POLICY REPORT DEVELOPMENT AND BUILDING

Report Date: May 27, 2008
Author: Michael Naylor
Phone No.: 604.871.6269
RTS No.: 07131
VanRIMS No.: 11-3600-20
Meeting Date: June 10, 2008

TO: Vancouver City Council
FROM: Director of Planning
SUBJECT: CD-1 Text Amendment - 711 West Broadway

Figure D4 — Section B-B through proposed development from 8th Avenue to Broadway
(See Appendix G, page 7 for section lines and page 8 for Section A-A)

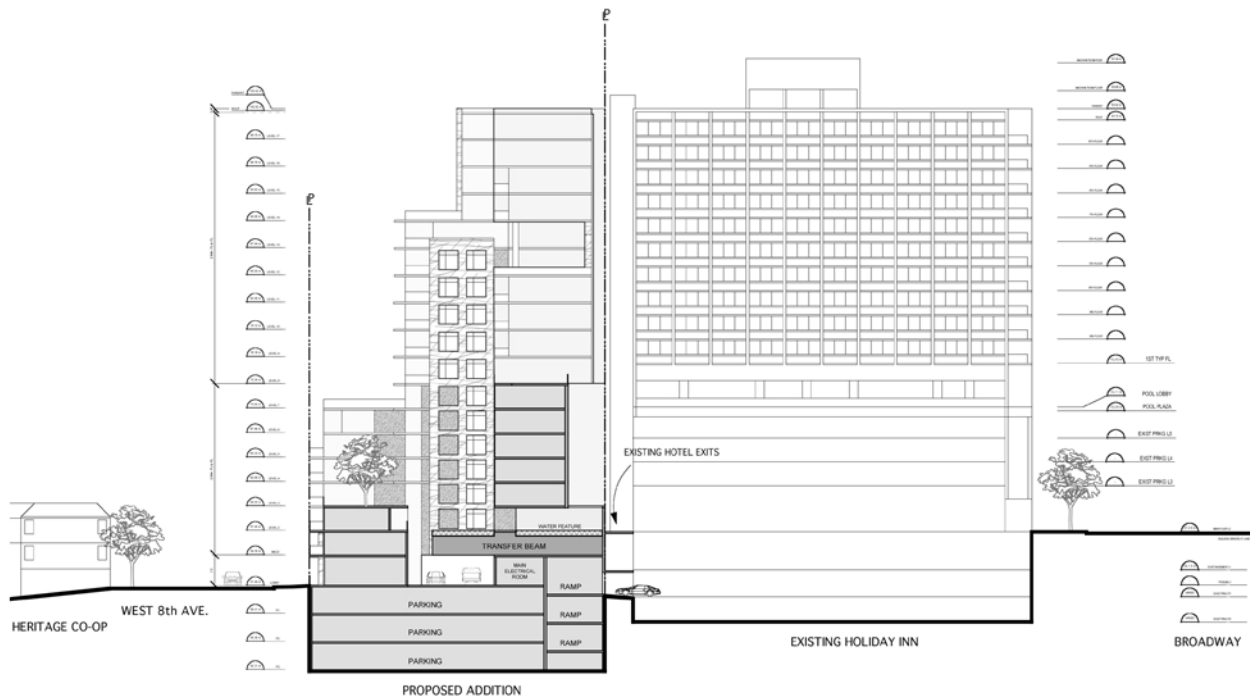
Shadow Impact of Proposed Building Form — The applicant provided shadow studies of the proposed development during summer solstice and during spring/fall (March 21st and September 21st) equinox. At the request of the Heritage Co-op across 8th Avenue from the development site, they also provided a study during winter solstice, although staff do not typically consider winter shadowing because the impacts are usually too severe with even one- and two-storey building forms.

The existing Holiday Inn tower, at 17 storeys, already creates a large shadow that impacts the surroundings. The studies show the incremental effect on shadowing with the addition of the proposed development. During the summer solstice, the Holiday Inn's shadow falls mostly on the surface parking lot to the north. With the proposed development, the summer shadow extends into the street, but it does not extend onto the existing developments across the street. There would be no incremental impact at that time of the year.

Figure D7 – Shadow at 2:00 p.m. during equinox (March 21st and September 21st)

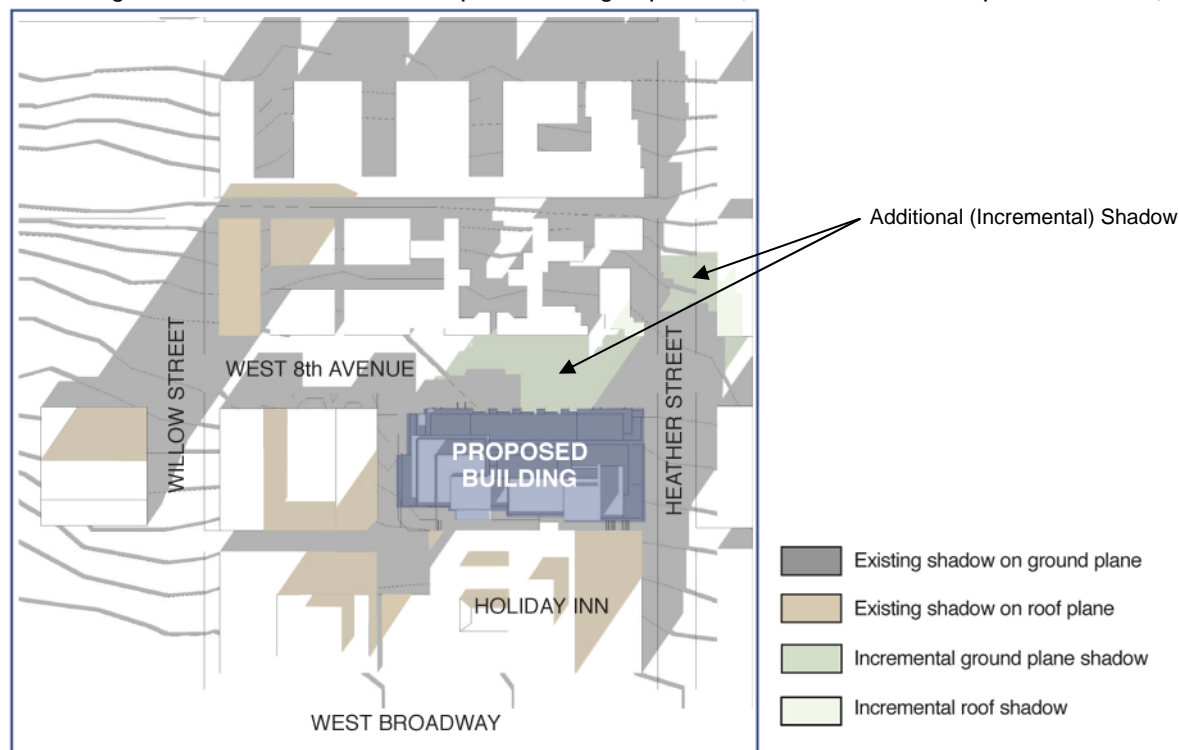
During the winter solstice, when the shadows of all buildings are very long, Fairview Slopes is highly impacted. Most street and courtyard ground planes are completely shaded. Units in the front of the Heritage Co-op near Heather Street do receive some sunlight during the winter morning, as do some of the upper-level units in the courtyard at various times of the day. The effect of the proposed development is to add more long shadow that may diminish some of these existing sunlight opportunities for courtyard units, although Heather-fronting units would not be further impacted.
